**NLR Planning Commission**  
**August 10, 2021**  
**Agenda Meeting / Public Hearing 4:00 PM**

**North Little Rock Planning Commission**  
**Regular Meeting**  
**July 13, 2021**

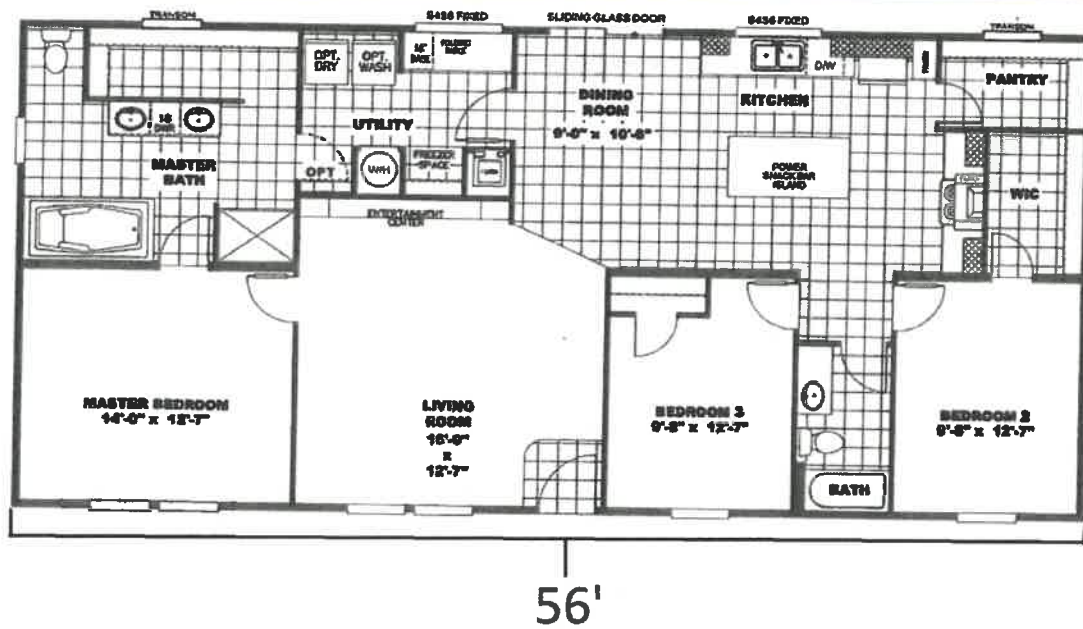
**DESIGN REVIEW COMMITTEE COMMENTS:** The Design Review Committee requested that the applicant provide an accurate site plan before they made a recommendation.

1. Provide a scaled and accurate site plan showing proposed home location, property lines, and driveway location. Label the dimensions of the home, dimensions of the lot, and building setback lines.
2. The property is located in flood zone AH. Meet the City Engineer's recommendation that the floor elevation is a minimum of 3' above the ground elevation.
3. Apply for a floodplain permit from the City Engineer's office.
4. Modular home to meet the requirements of the Arkansas Fire Prevention Code.
5. Modular home to be The Anniversary 2.0 as shown in documentation.
6. Provide a letter from the manufacturer / builder that states the home meets all Arkansas and North Little Rock codes.
7. Provide a continuous masonry foundation.
